# ControlLogix Drive Module (v1.20)

(Cat. No. DMF30)

These release notes correspond to major revision 1, minor revision 2 of the SF3000 Interface (1756-DMF30) firmware. Use this firmware release with:

Publication 1756-RN685A-EN-P - September 2010

### Alternator Power Selection, P2200 [PMI Drive Config], B14 "AltrnatorPwr"

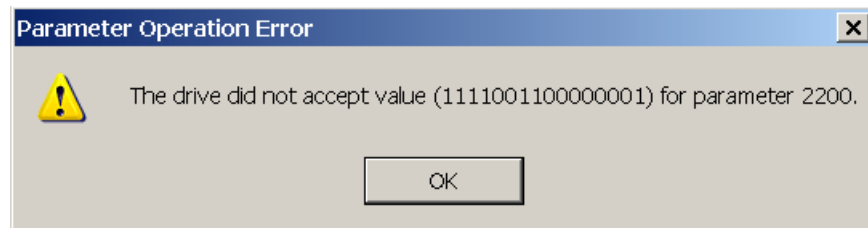
For cases where alternator power is used instead of utility power, this option has been added to allow the drive to better track the AC Line Frequency. The trade off is that the line frequency filtering is reduced when the Alternator Power option is selected.

The program defaults to selecting "Alternator Power," to provide the best frequency tracking, whether connected to the Utility power or Alternator power. It is recommended to have "Alternator Power" selected.

Note: The program will not allow the Alternator bit to be changed unless both the FML and the CML are not running. The error message shown below displays if an attempt is made to change the state of the Alternator Bit with the FML or the CML active.

## Parameter 166 [Motor Cntrl Cmmd], Bit 21 Changed to “Reserved”

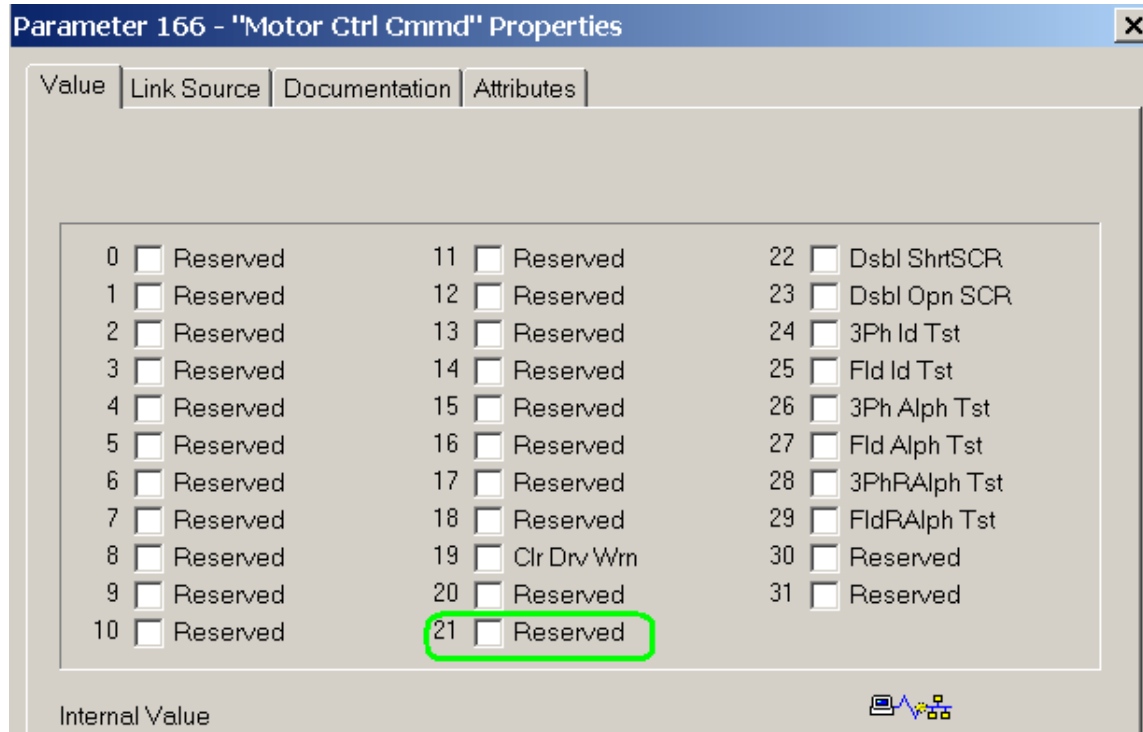
Parameter 166 [Motor Cntrl Cmmd], bit 21 “Dsbl Fld Wk” should have been defined as “Reserved”. Because CEMF regulator is not available in the DMF30 drive module, this bit has been changed to “Reserved”.

**Figure 1 - Case 1, 3 Phase (Non-Regen), 2 Quad with Field**

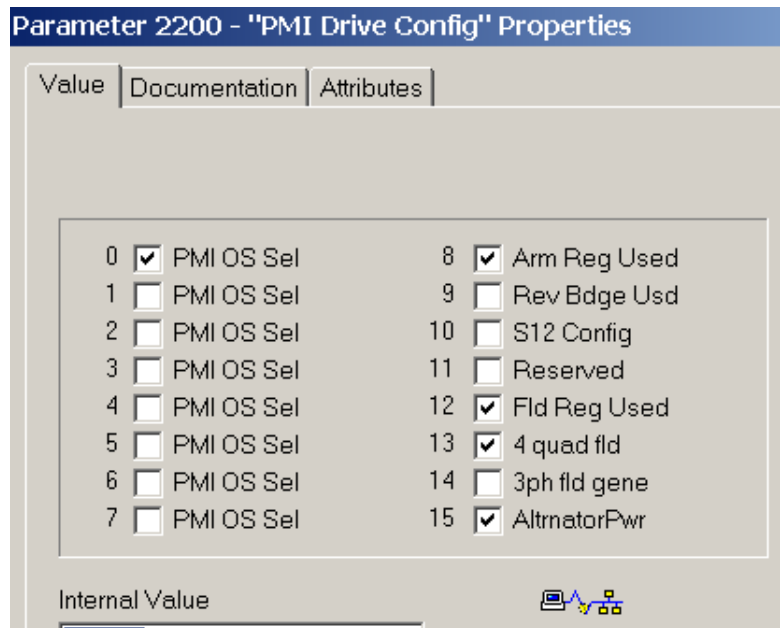
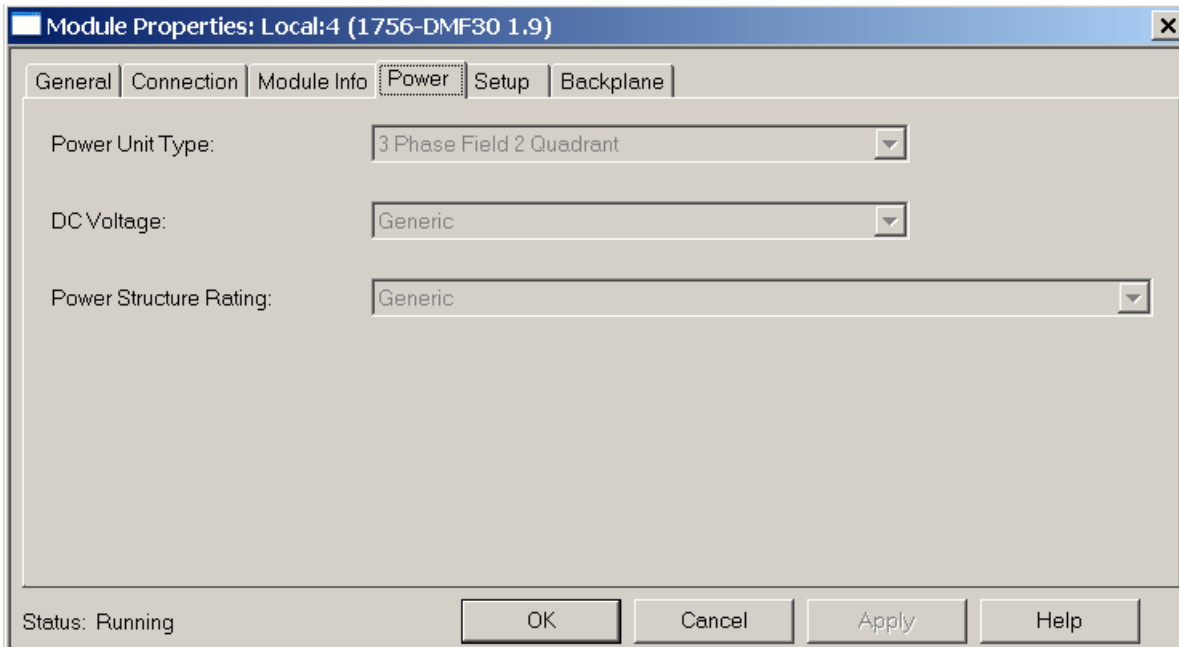
The power code selections were updated to reflect that there is only an S2R Field Power Module available as well the default parameters appropriate with the power code selected.

Note: Parameter 2214 reflects an earlier build of the software during the program updates. The number that appears in parameter 2214 for the final build is “18”.
